S A V A N N A H H I S T O R I C D I S T R I C T
B O A R D O F R E V I E W

REQUEST FOR CERTIFICATE OF APPROPRIATENESS

MPC File No.: **26-001857-COA**

Address: **444-446 Tattnall Street**

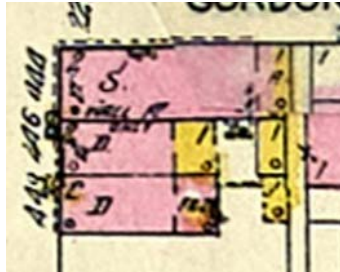
addition was added to the rear of 444. While gable roof entrances were not present in 1888 (see Sanborn at right), by 1916 they were present on the residential units but not on the commercial entity. In 1973, the rear addition of 444 shows that it was used as a garage (see below).
